B D A Associates, LLC
Engineering Consulting Group

Project: 5992-09-82/83/85/86/87/88, CTH M
Raymond Road, Unacceptable Storm Sewer Pipe
Subject: Concrete Pipe Tunnel Restoration Plan

This cover letter will provide an executive summary of the Raymond Road Elliptical Pipe Restoration work. BDA Associates, LLC objective was to provide a design:

16 DRILL HOLE LAYOUT AT +/- 16" O.C. AT CONCRETE PIPE JOINTS
POLYURETHANE GROUT PLUG AROUND PERIMETER OF PIPE JOINTS

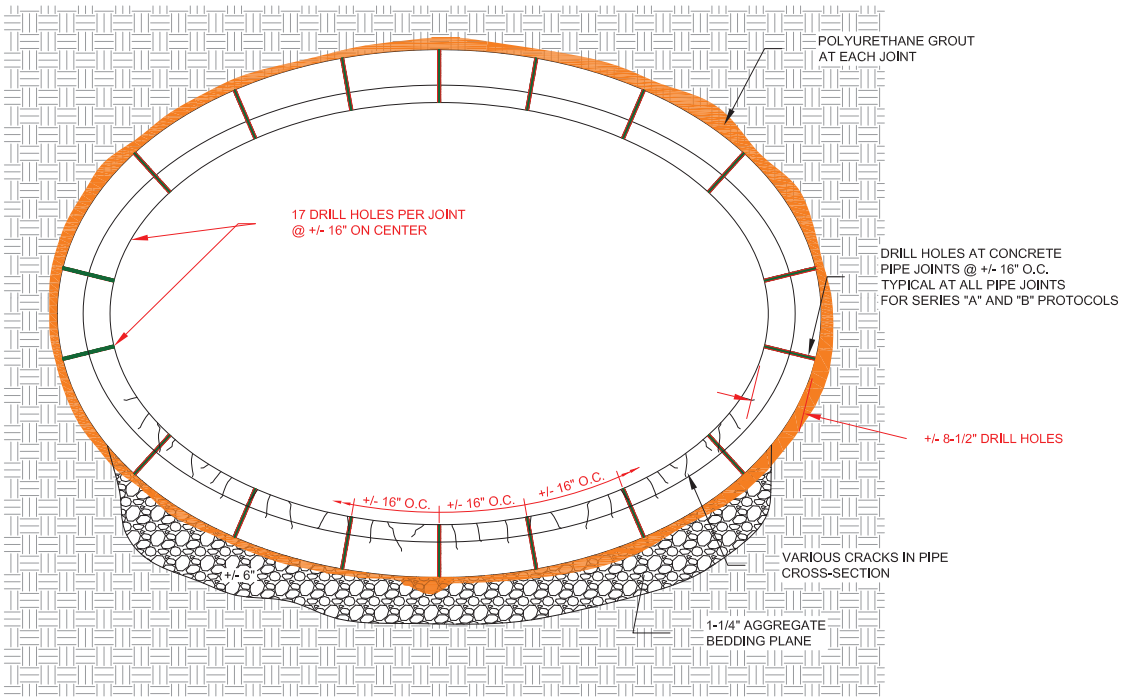
- Per joint according with Project Drawing 16A, see image 1.a.
- The cement grout holes (8 each) located between joints in the haunch area, see Image 1.b.
- Drill holes for crack interception (cracks with width greater than 0.021 inches).

4 CEMENTITIOUS GROUT, HAUNCH AREA INJECTION
SECTION, TESTING AND PRESCRIBED GROUT QUANTITIES

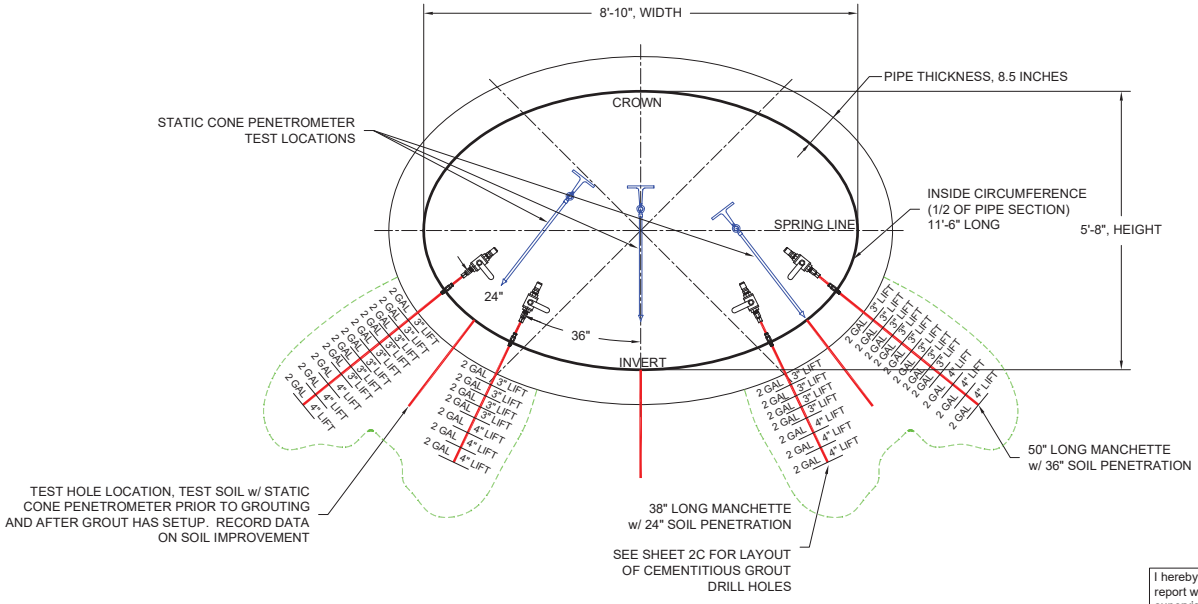
In series "B" the preference is to use "uniform disbursement" protocol as shown on sheets 4B and 5B. In contrast, sheet 4C, in series "C" drawings show the "bottom up" protocol.

the BDA plans and specifications it will satisfy the verification of the pipe bedding installation. A mock-up test section will have to be done per sheet 4C to verify grouting and testing methods.

FIGURE 1

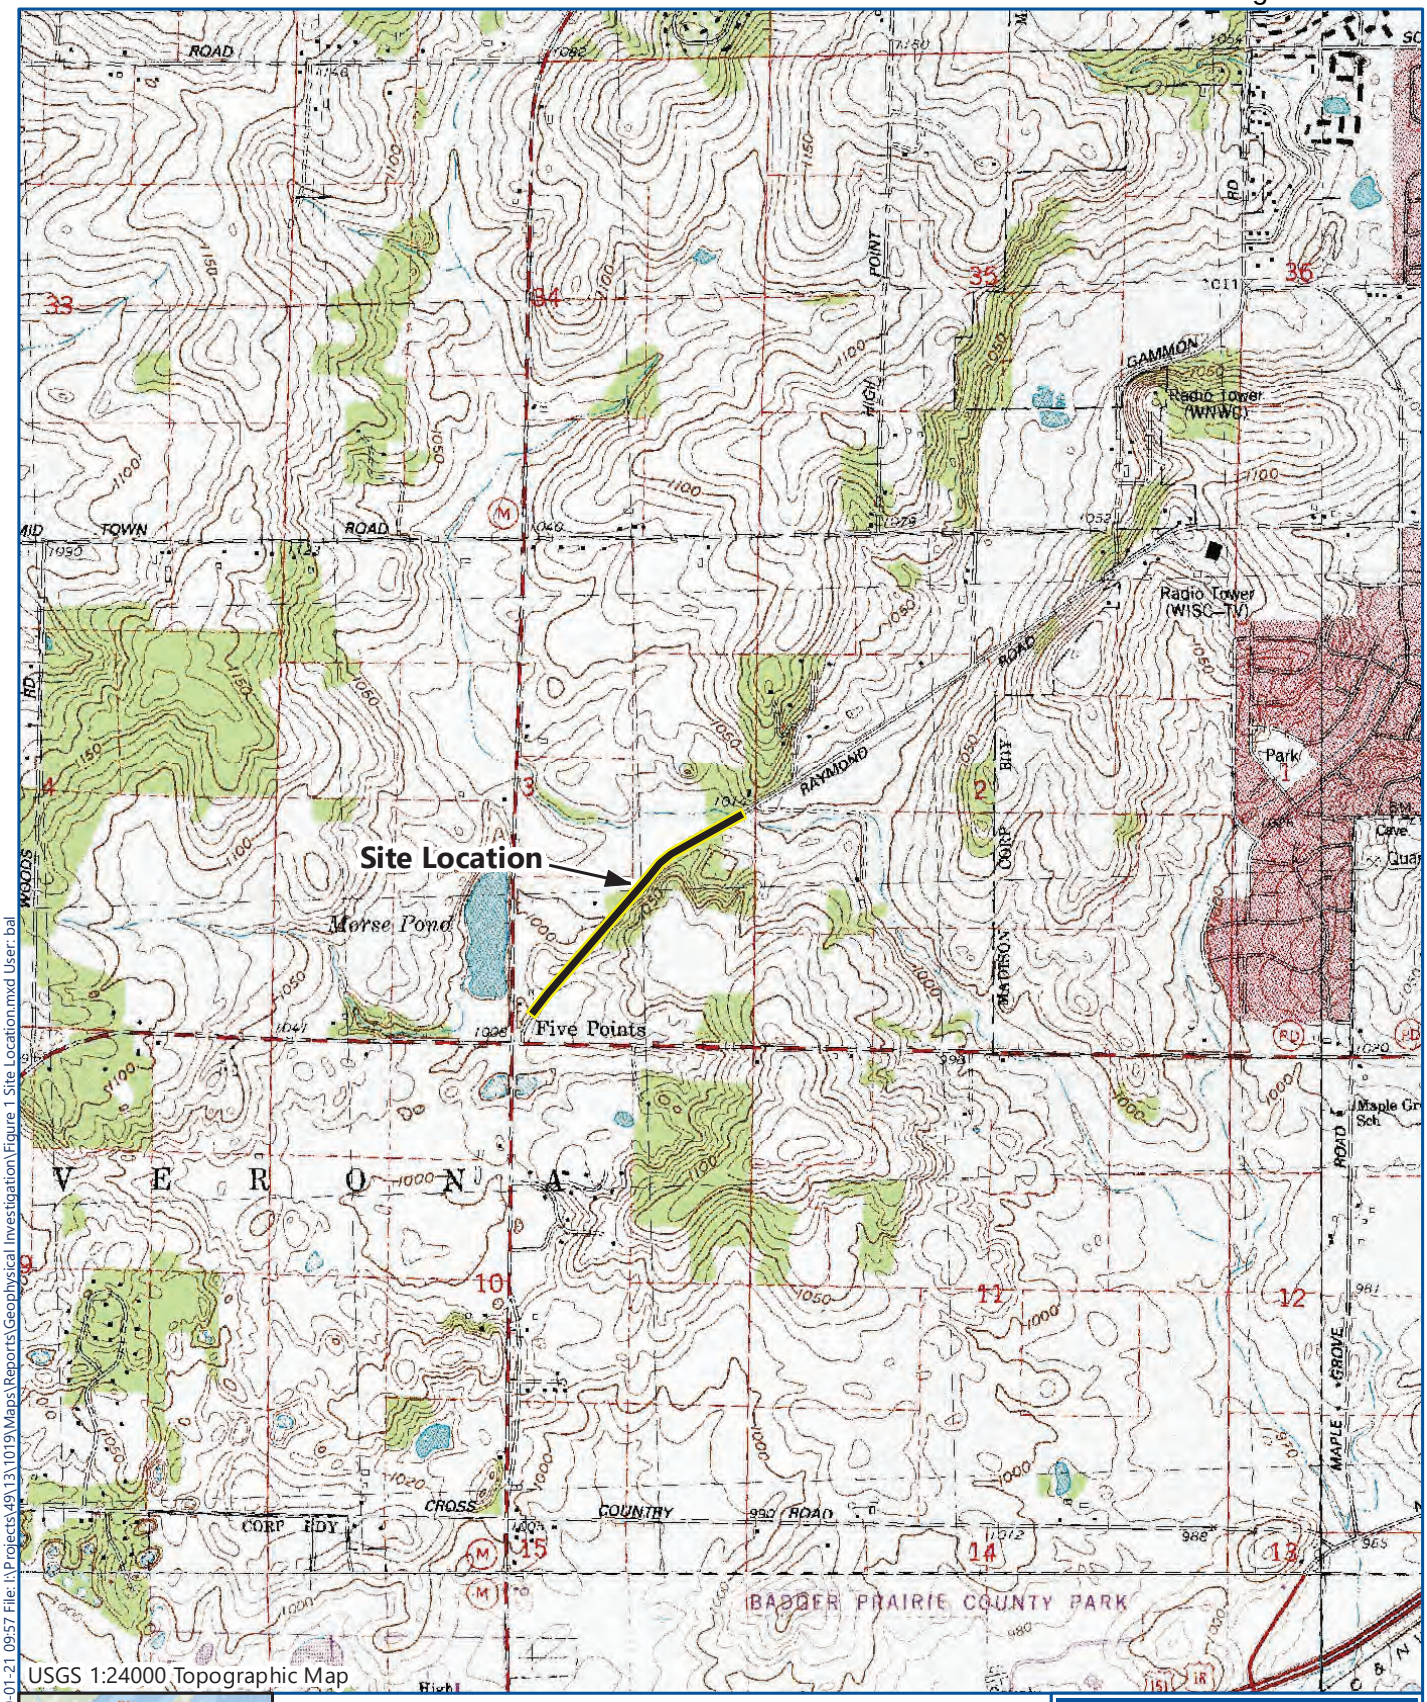
- Figure 3 is missing several Subsidence Feature Locations as compared to WisDOT documentation. Plan discuss five reported subsidence areas, but the provided Figure 3 indicates six locations. This needs to be clarified.

- *{Figures 3-5} We hereby amend the plan to include the 6 locations shown on Figure 3. Our plan is to address all known subsidence features and complete a geophysical investigation to discover and remediate any additional subsurface areas of concern within the project footprint. If there are other features we are not aware of please note them on the map and they will be incorporated into the scope of work.*
